Product Change Notification

Change Notification #: 110905 - 01
Change Title: Intel® Desktop Board DH67CL, Boxed and Bulk
PCN 110905-01, Product Material
Replace PWM CONTROLLER
Reason for Revision: Add CPU Socket Cover change
Date of Publication: August 10, 2011

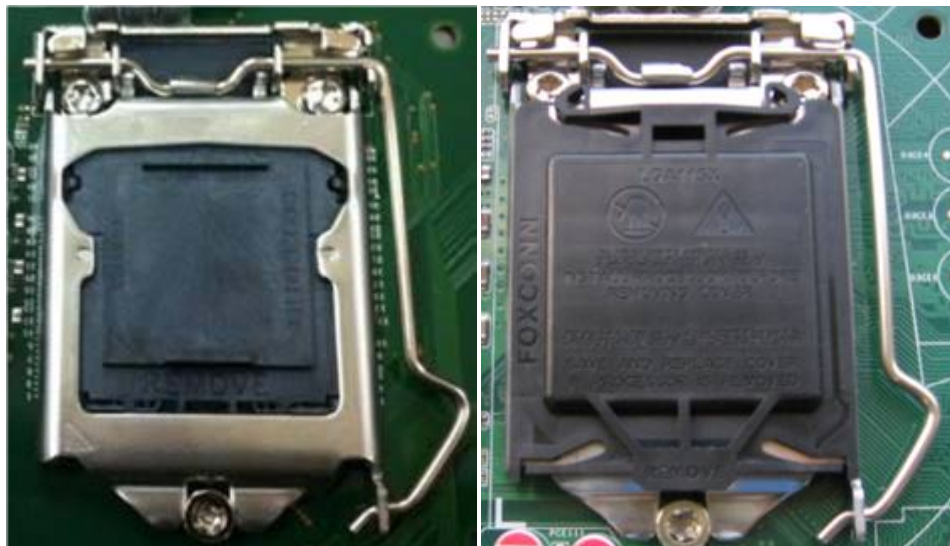
1. The Pulse Width Modulation controller CHIL 8104 upgraded from version E4 to E5 to enhance performance.
2. The CPU socket cover will be changed to the ILM version.

Current socket with PNP cover

New socket with ILM cover
